**PINEVIEW HEIGHTS SUBDIVISION,**  
**RESUBDIVISION OF LOTS 1 & 34**

APPLICATION NUMBER 8 DATE July 9, 2015  
APPLICANT Pineview Heights Subdivision, Resubdivision of Lots 1 & 34  
REQUEST Subdivision

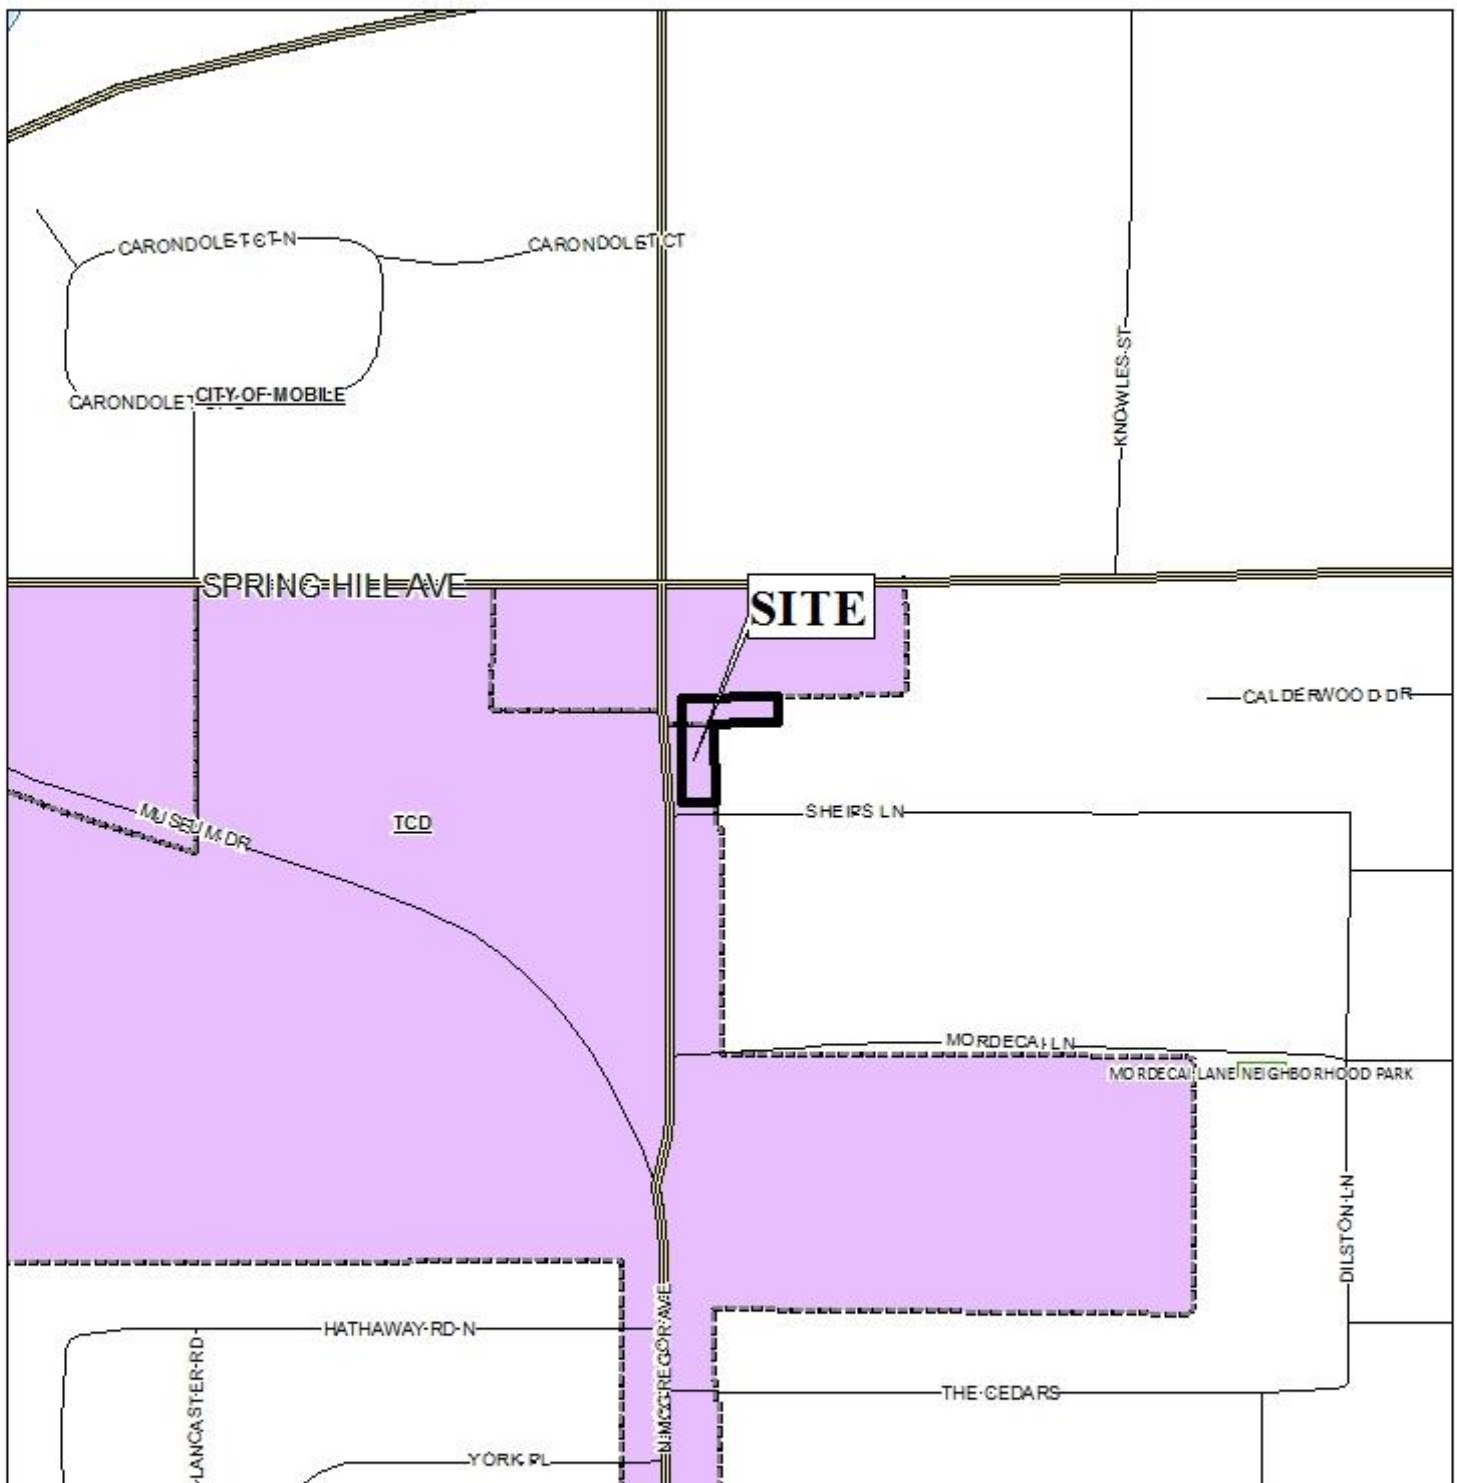
The applicant has voluntarily chosen to develop the northern-most lot under Section 64-3.H. Traditional Center District of the Zoning Ordinance, commonly known as the Village of Spring Hill regulations. As such, the R-1, Single Family Residential property, due to its location within a "*Neighborhood Center*" sub-district, can be developed commercially and can have a building built up to the front and side property lines. These reduced setbacks supersede those contained within the Subdivision Regulations, thus the front setback requirement of Section V.D.9. should be waived.

The adjacent lot that is also part of this subdivision request is located in a "*Neighborhood General*" sub-district, and the adjustment of the common lot line will result in a split-zoning condition for the proposed Lot A (the lot that is being developed commercially). Thus a rezoning application is also necessary in order to fully resolve the issues created by the encroachment of the concrete slab across the property line.

As proposed, the adjusted property line will provide a sideyard setback of from 8 ¾ inches to 1 foot 11 ¾ inches for the existing slab. No side yard setbacks are required in the Neighborhood Center sub-district.

# DETAIL SITE PLAN

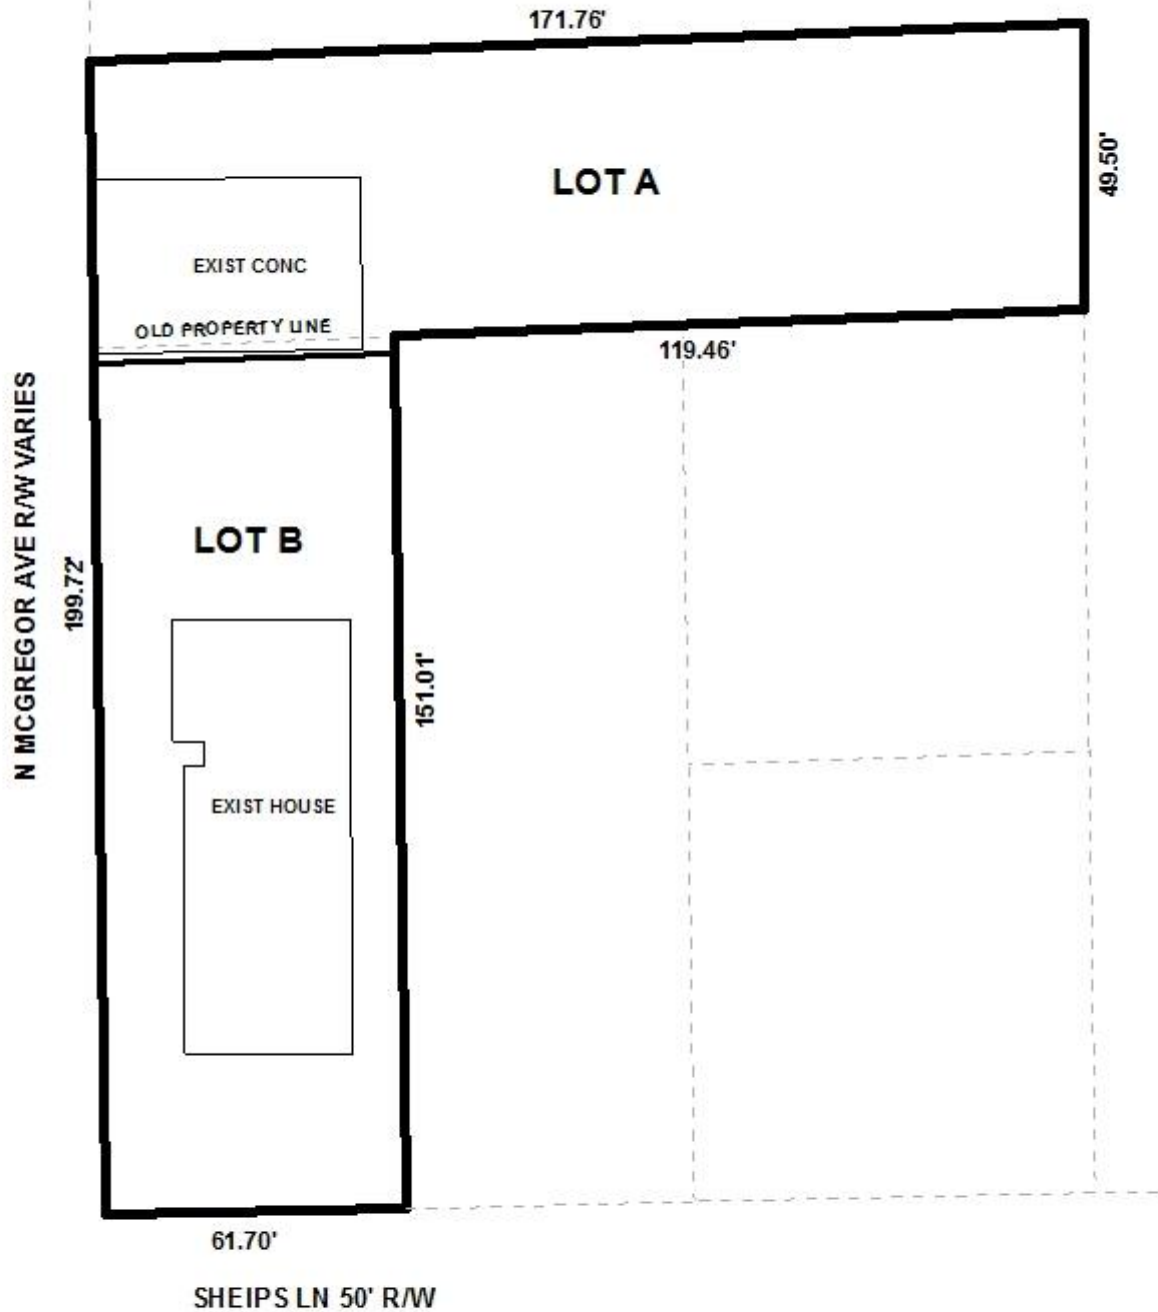
The purpose of this application is to resubdivide two existing lots to adjust a common internal lot line, to accommodate the slab of a building under construction that was inadvertently placed across the existing lot line. The applicant owns both properties.
